Texas A&M University
Locked Inc.

Sheet: /
File: STAR_BMS.kicad_sch

Title: BMS

Pack In

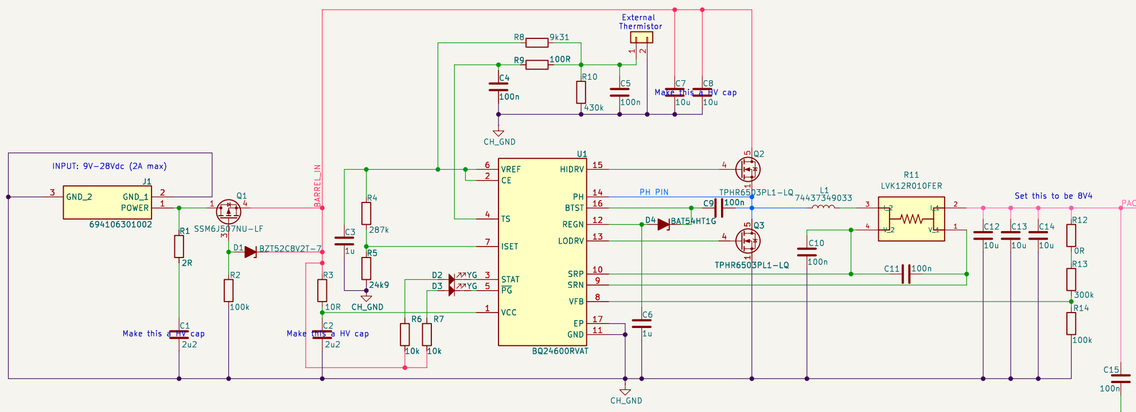
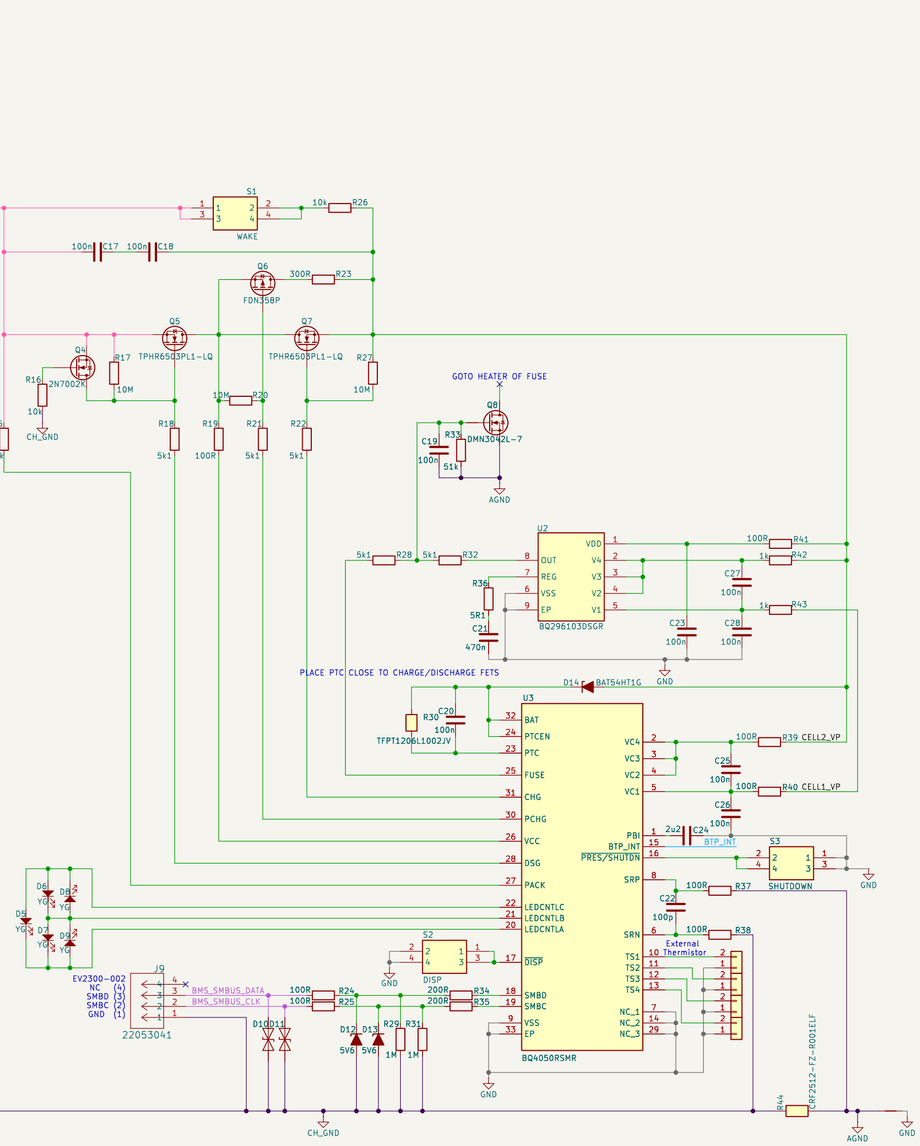
we dont need 2 connectors because of the current, we have 2 connectors because we are putting 2 batteries in parallel for more capcity
